**Fo81J, Fo81K, Fo81S; Fo8L9
BCTS Foghorn VIA
prepared by
RDI Resource Design Inc
November 7, 2015**

VNS Simulation of Landforms and Visual Sensitivity Units

Sandbox original without RDI Leave. Existing nonVEG in orange.

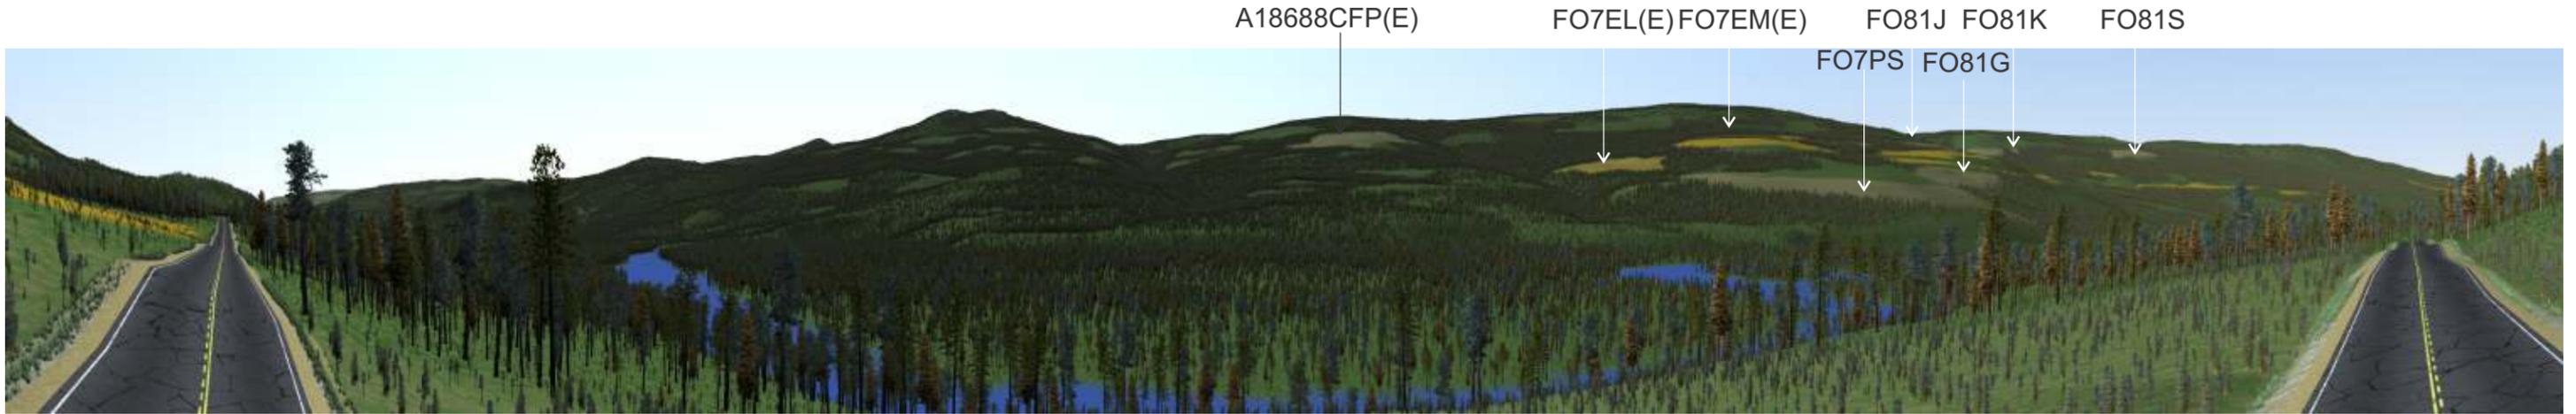
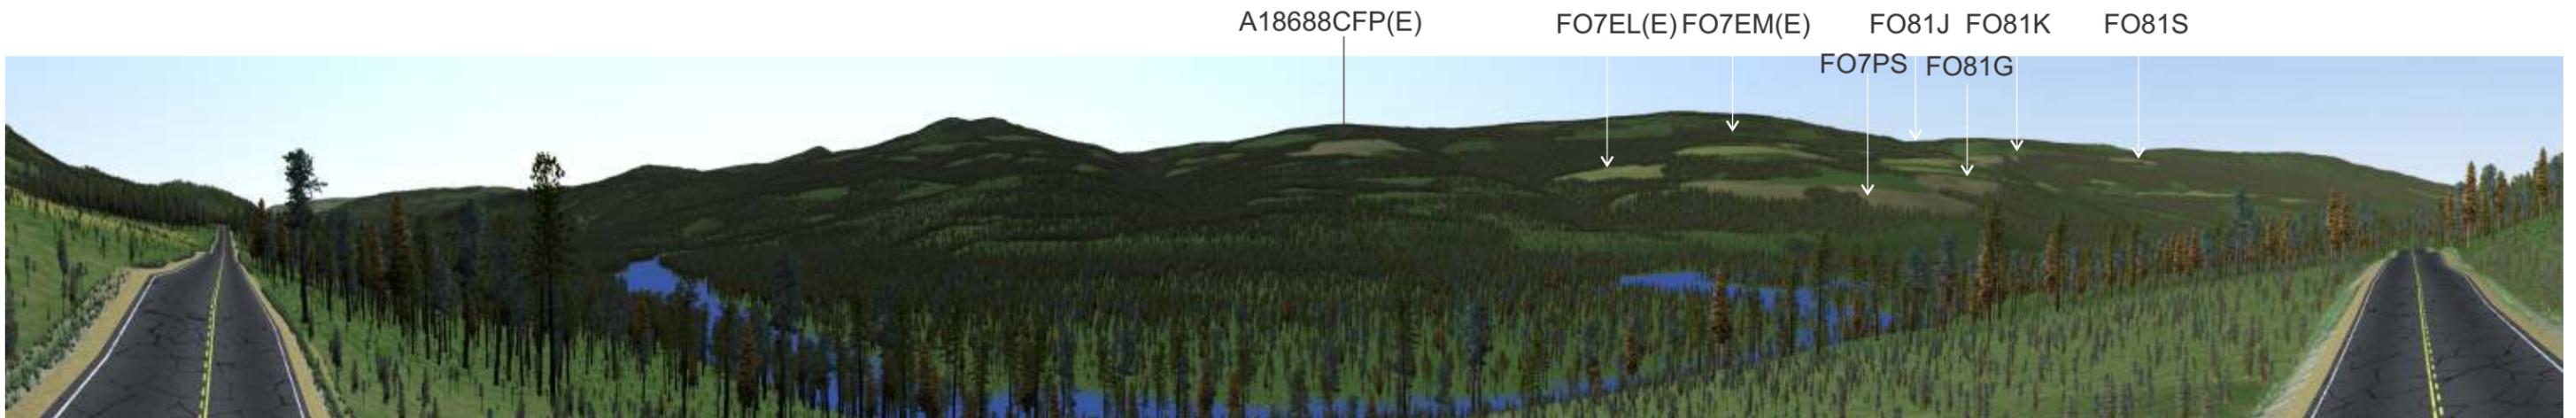
Fo7PS - reduced angularity, break in centre to strengthen visual force through block.

Fo81G - reduced angularity

Fo81S - reduced angularity

Note: Fo7PS and Fo81G considered in August VIA. Though simplistic, no further changes were made in this VIA for consistency.

McCorvie original without RDI Leave. Existing nonVEG in orange.

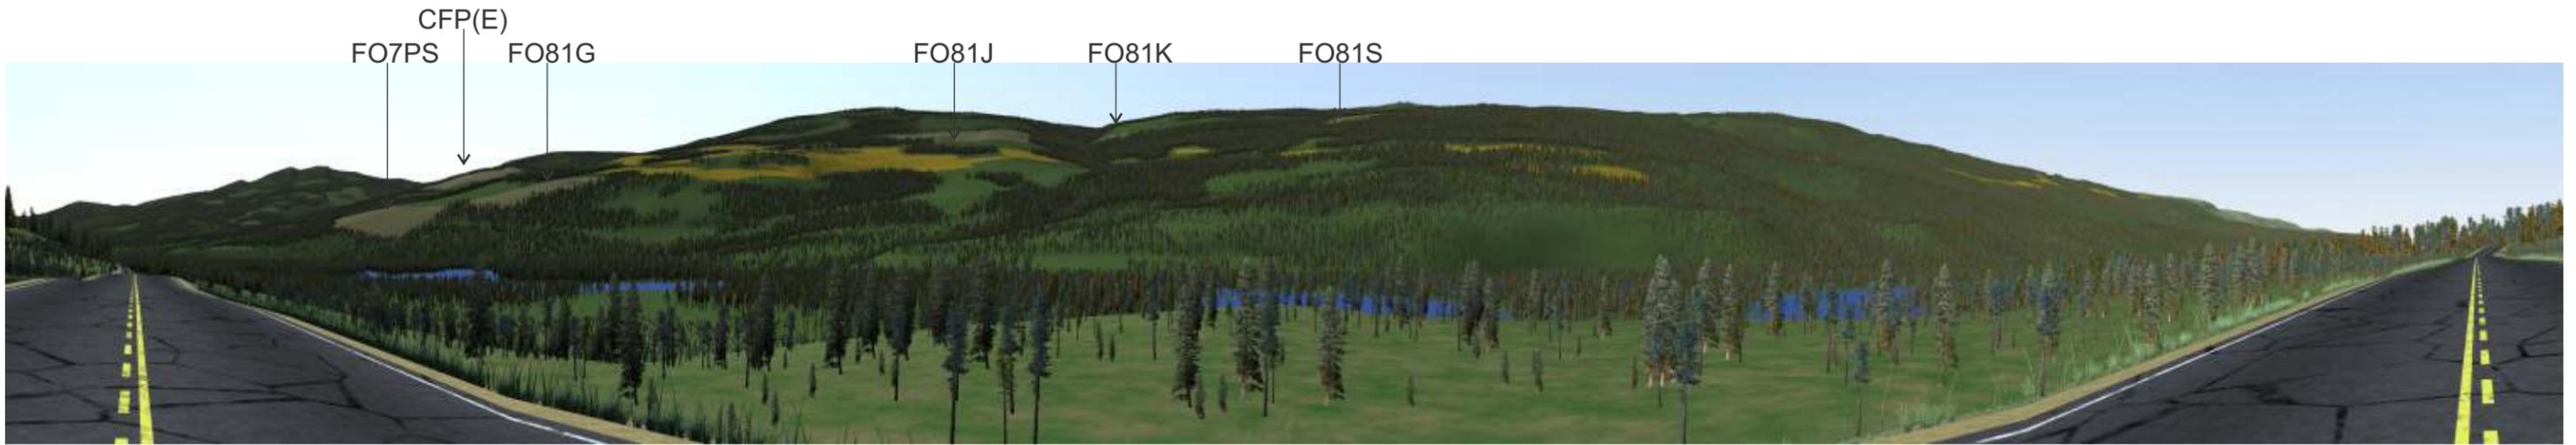
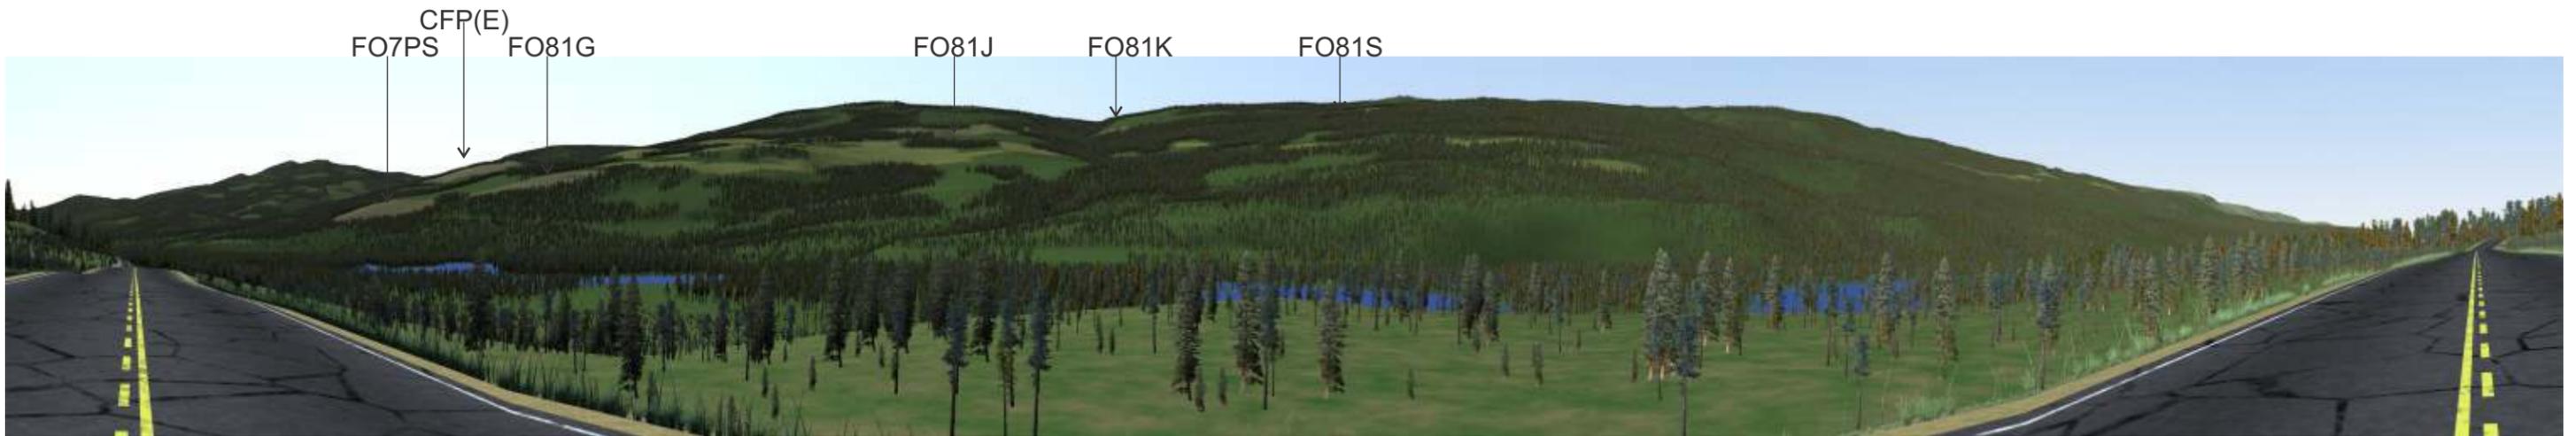
- Fo7PS - reduced angularity.
- Fo81G - reduced angularity
- Fo81J- reduced angularity
- Fo81S - reduced visibility

Note: Fo7PS and Fo81G considered in August VIA. For consistency, no further changes were made in this VIA.

Birch original without RDI Leave. Existing nonVEG in orange.

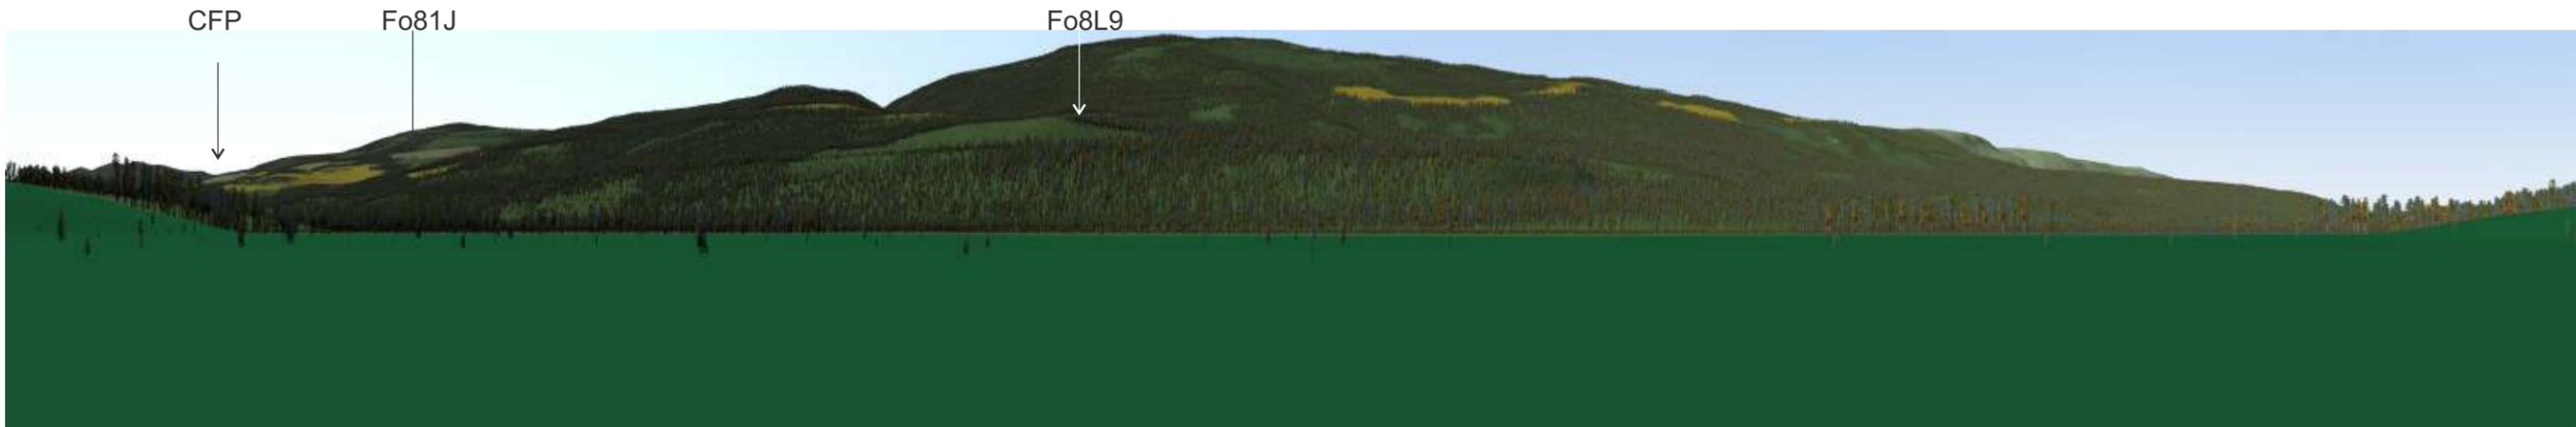
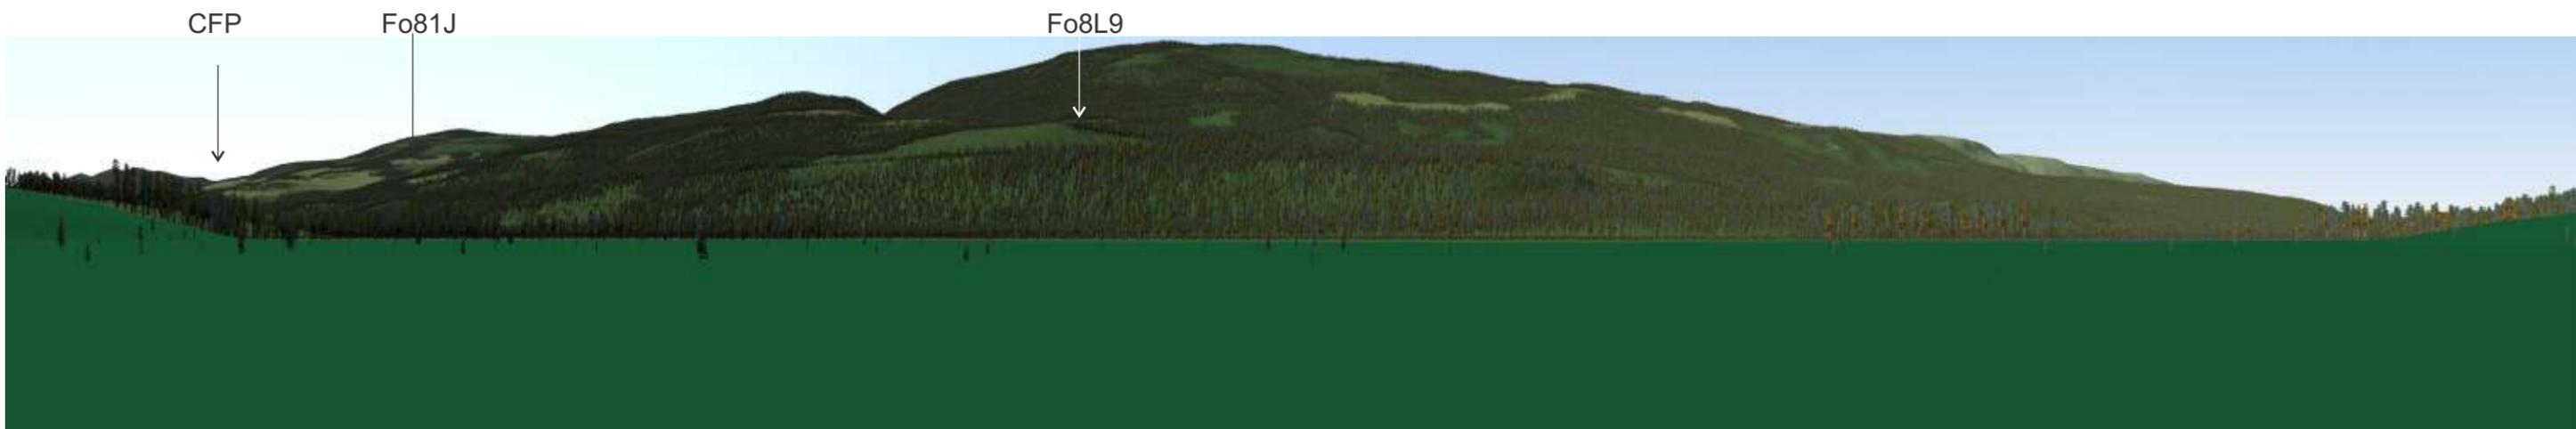
Fo81J- reduced angularity

Miller original without RDI Leave. Existing nonVEG in orange.

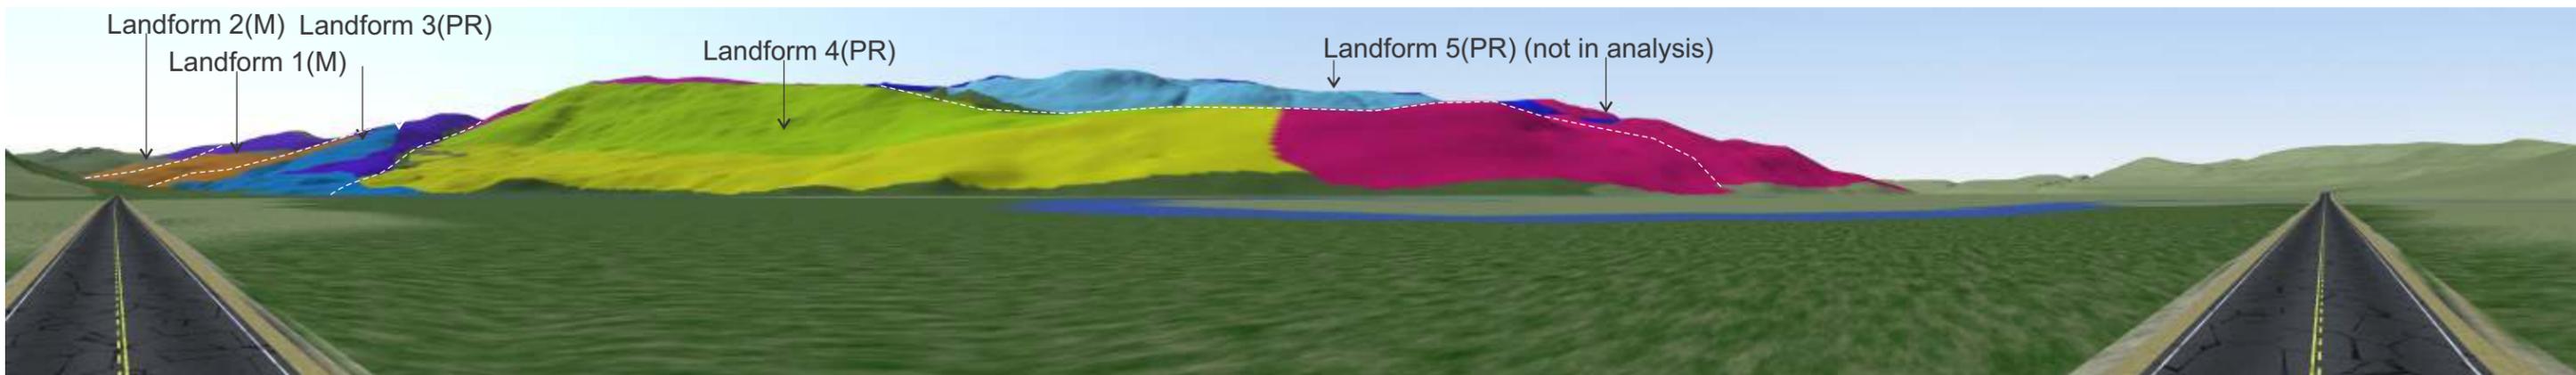
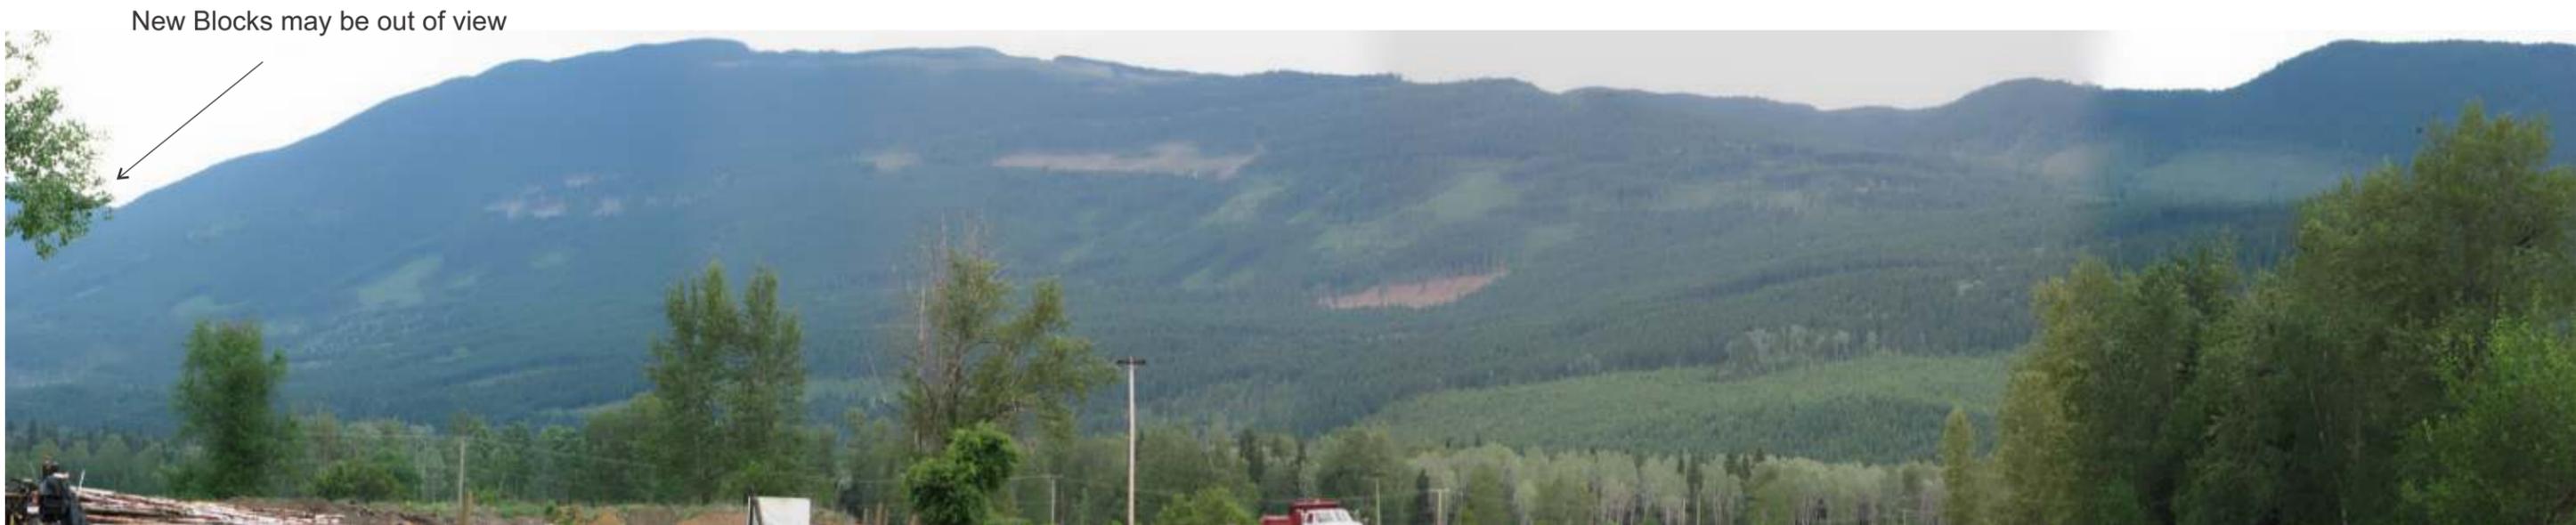
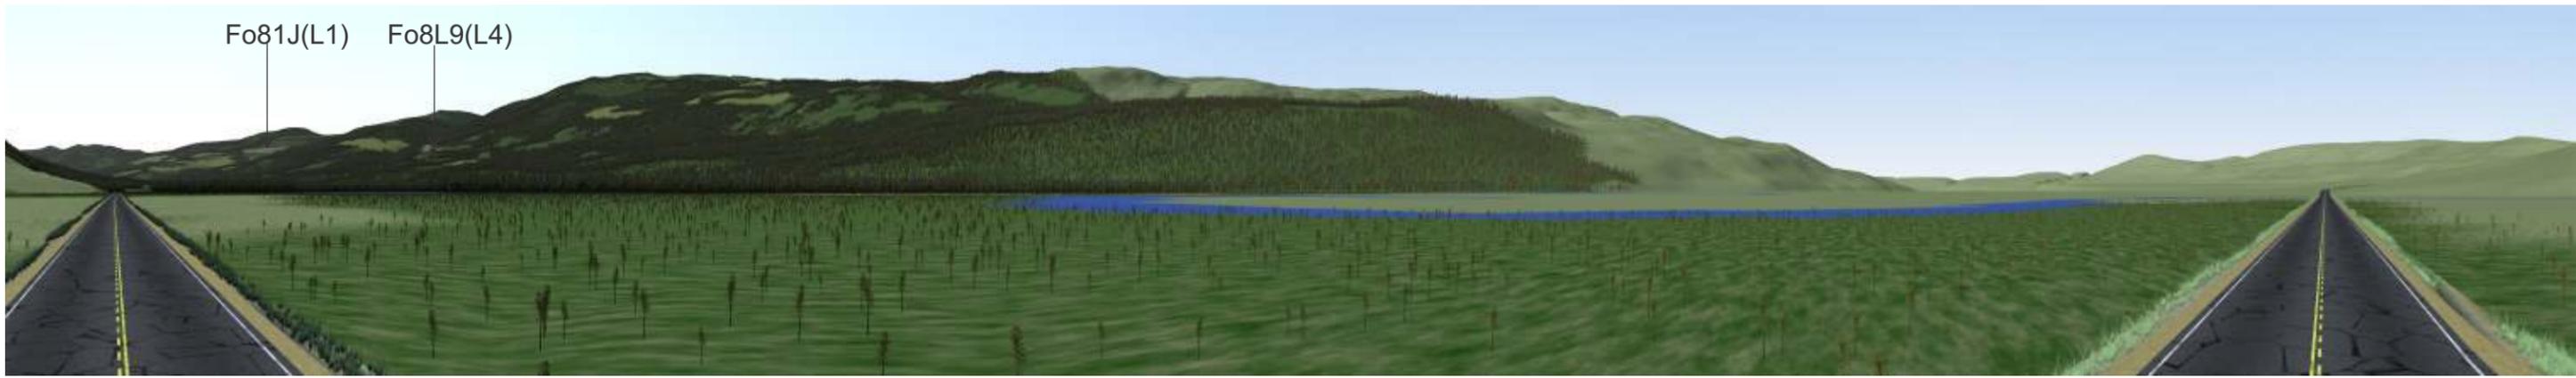
Fo81J- reduced angularity
 Window in to view the distinctions between the two scenarios for Fo81J.
